# **ADDENDUM NO. 1**

## **Middle Georgia Regional Airport (MCN)**

**PA PN 20202946.0003**

Issued: June 16, 2023

SHEET: **EA-301**

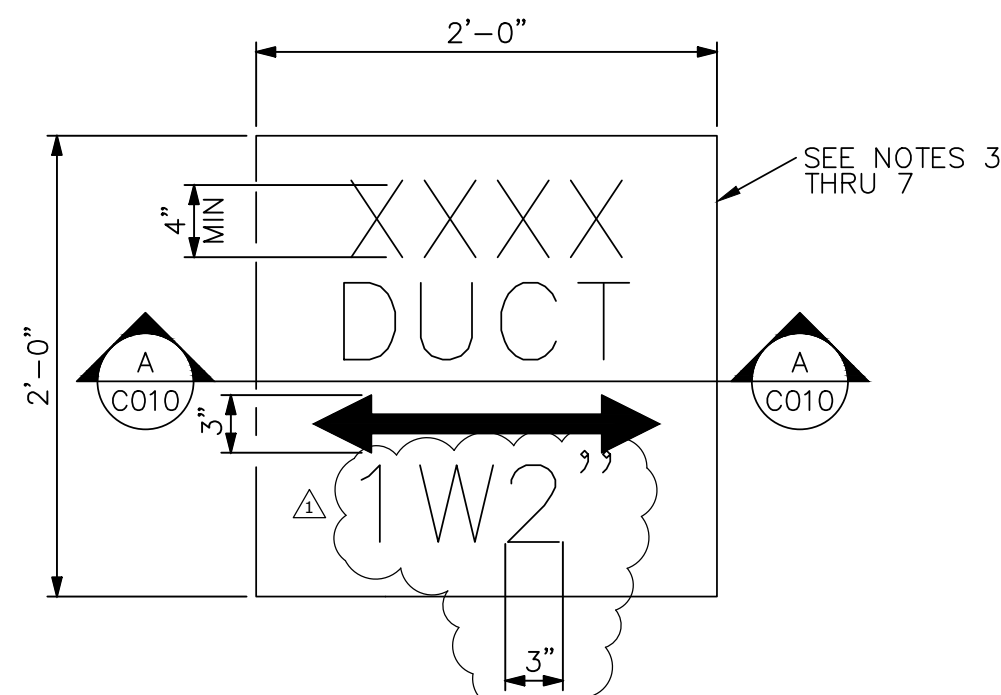
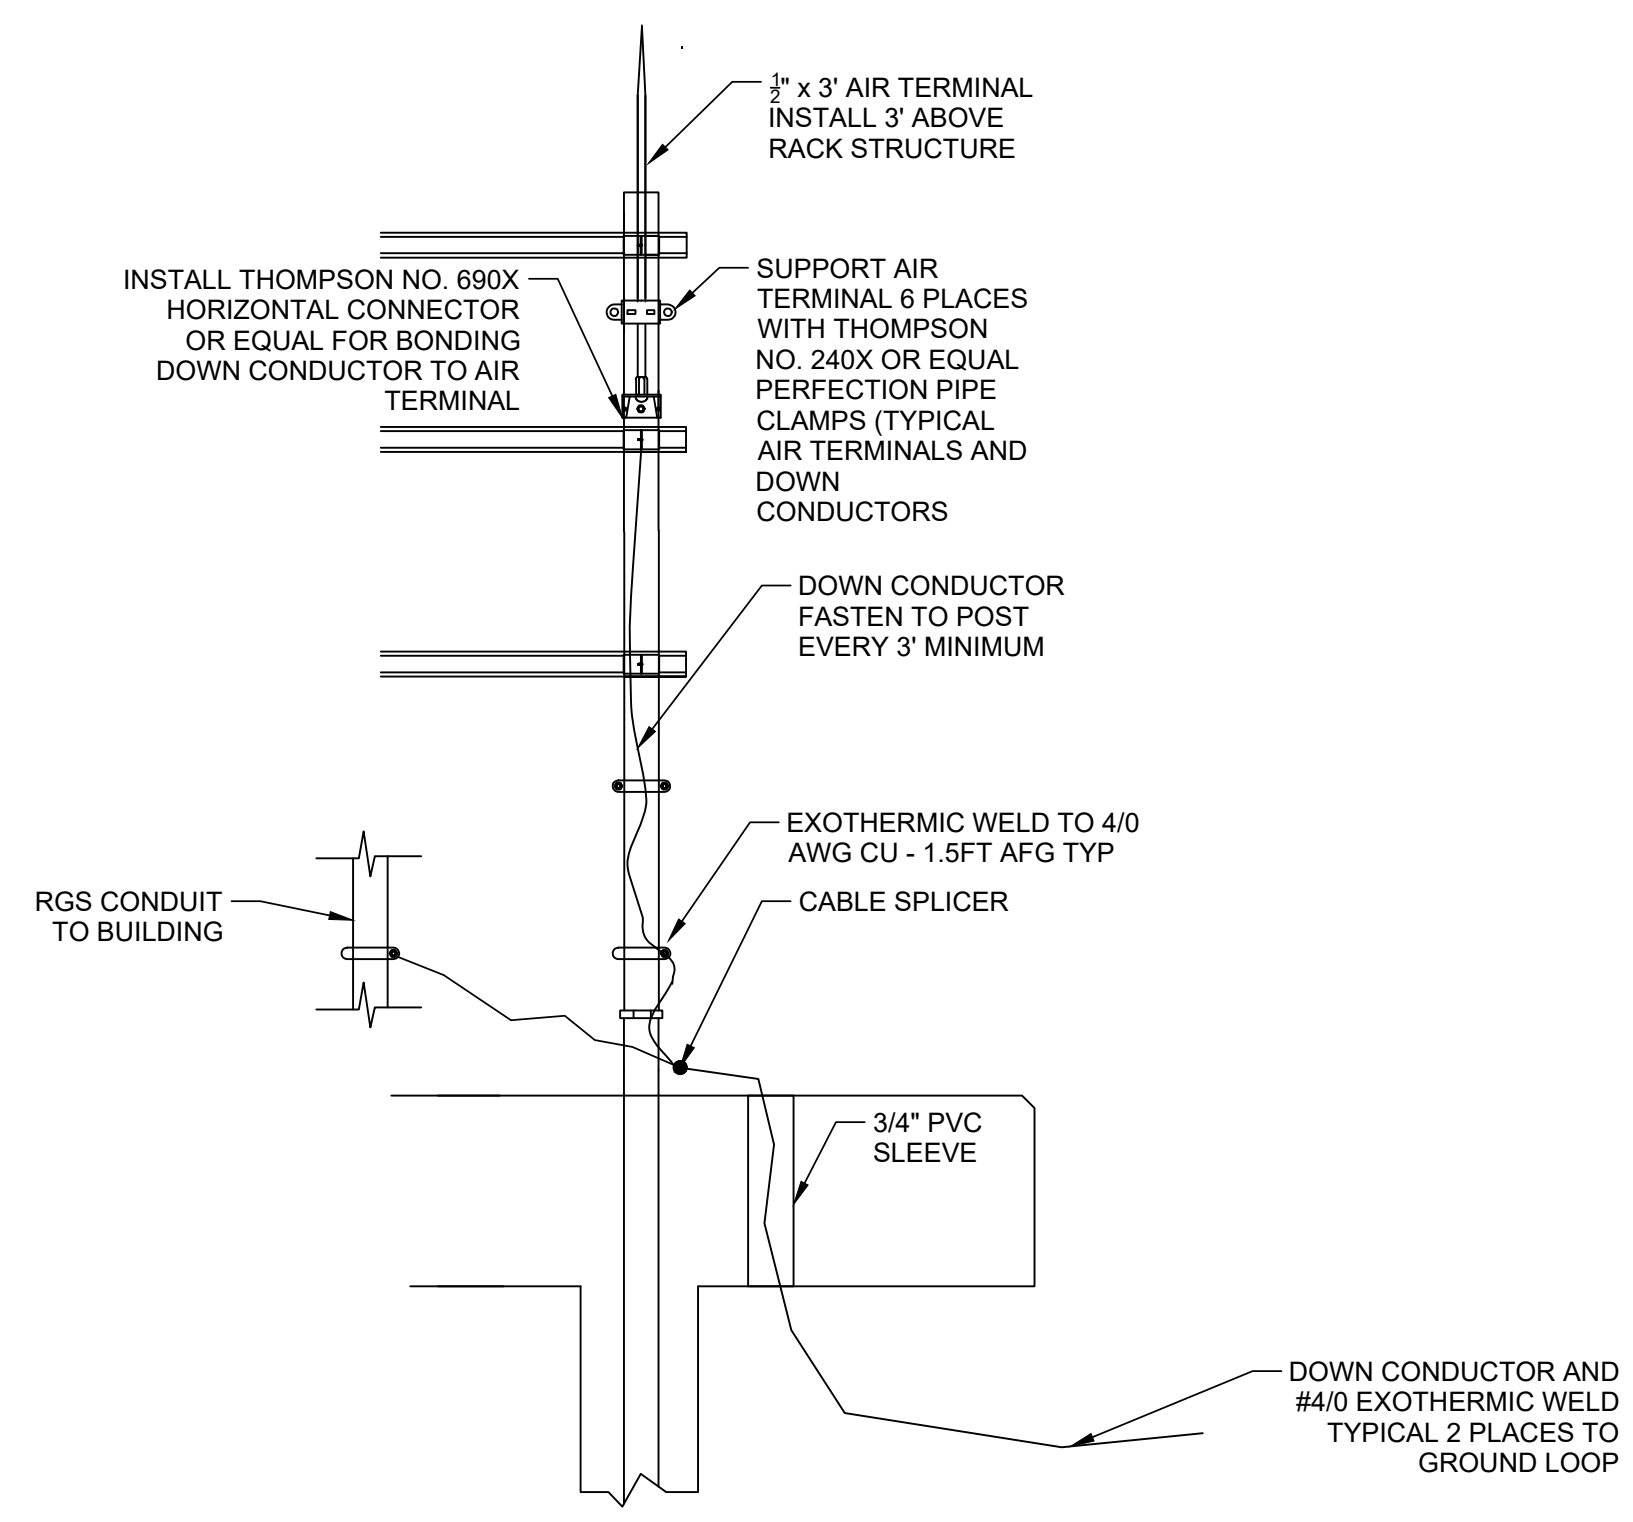
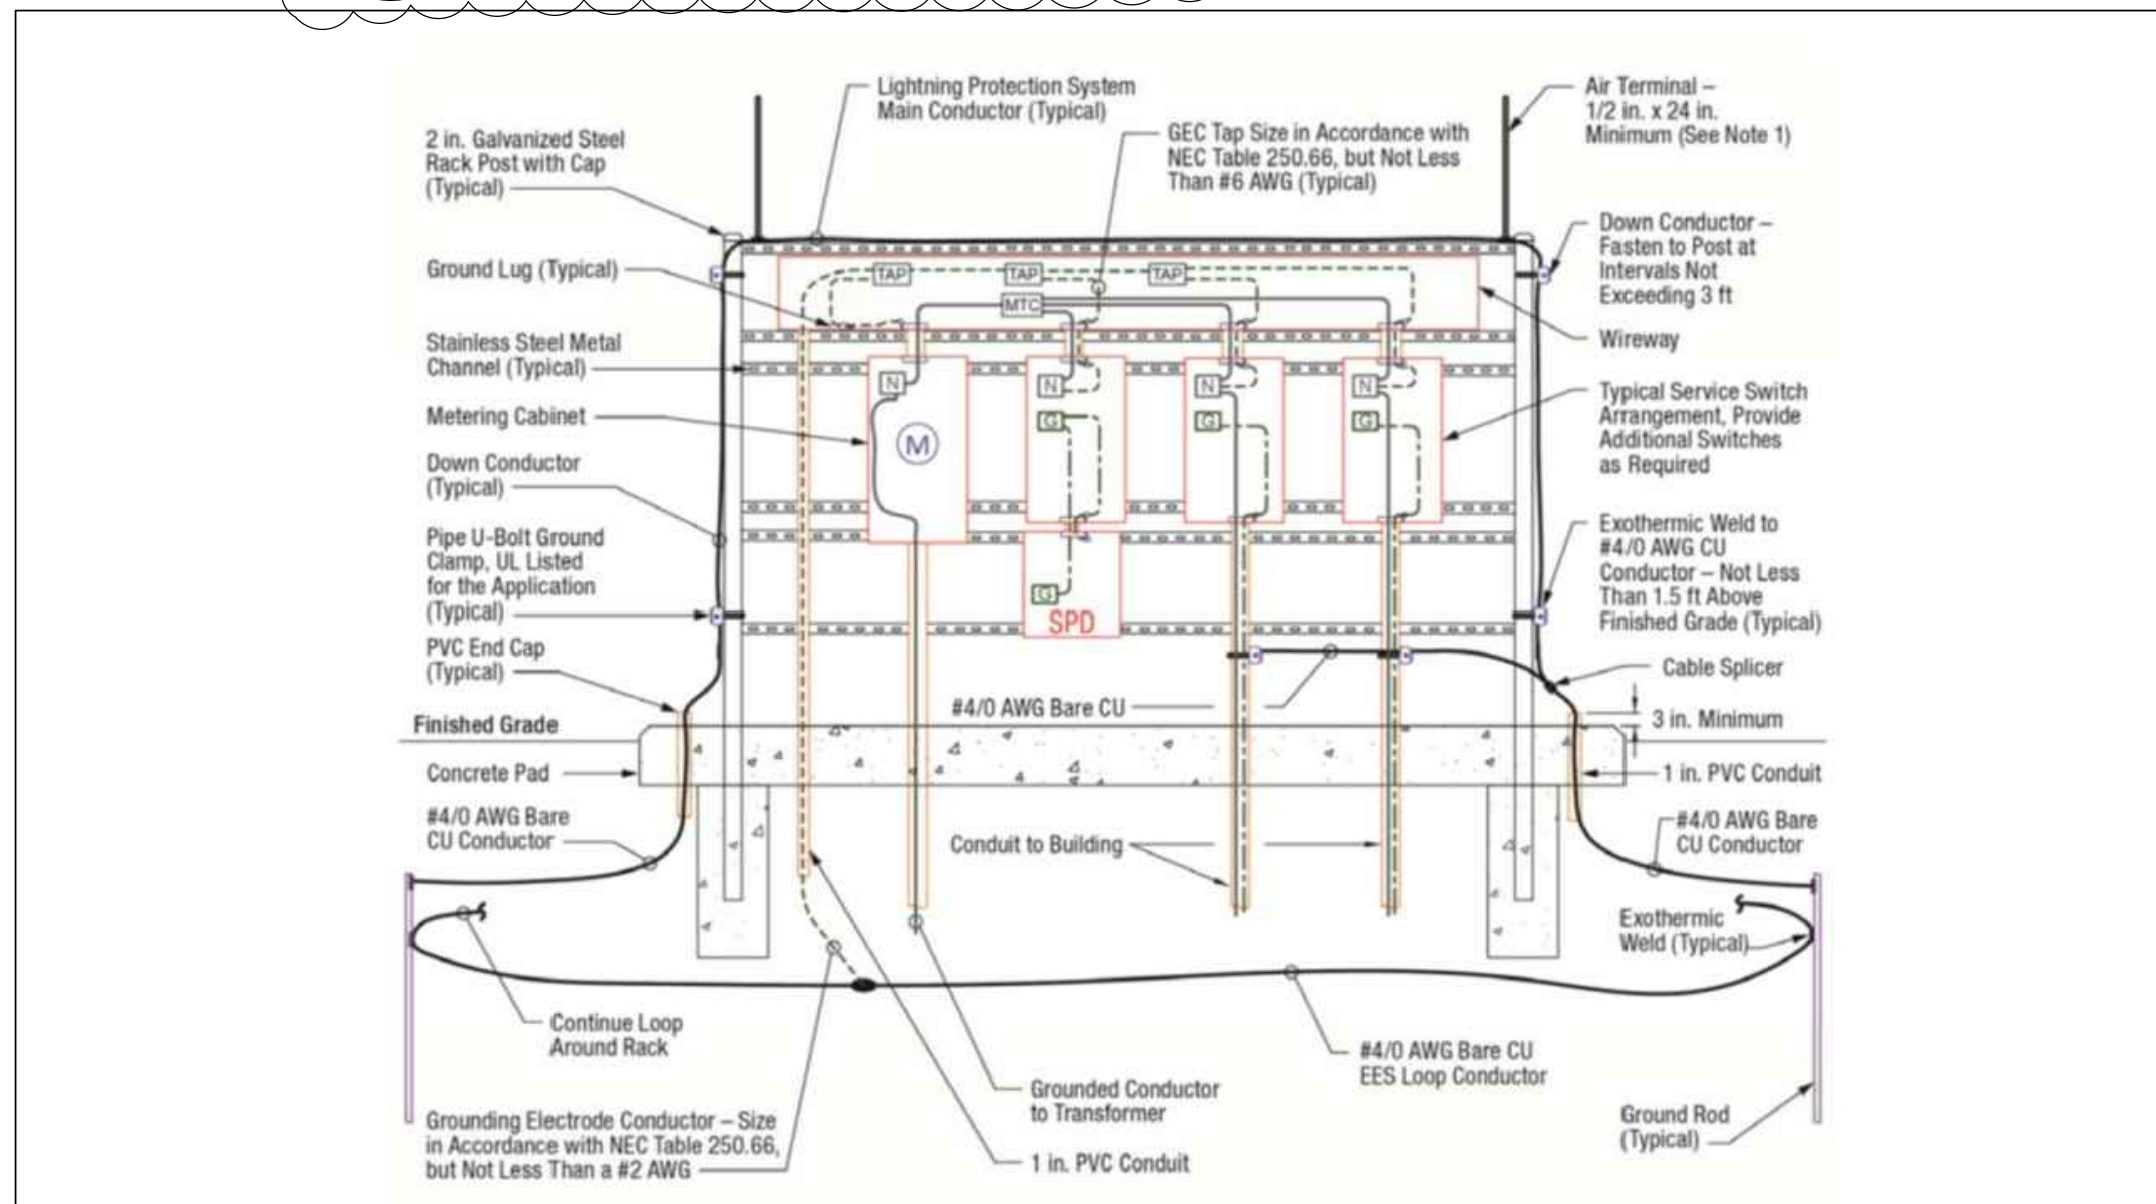
**REPLACE** electrical sheets with revised, attached sheets, EA-001, EA-101 through 103, EA-203, EA-204, and EA-301 through EA-304.
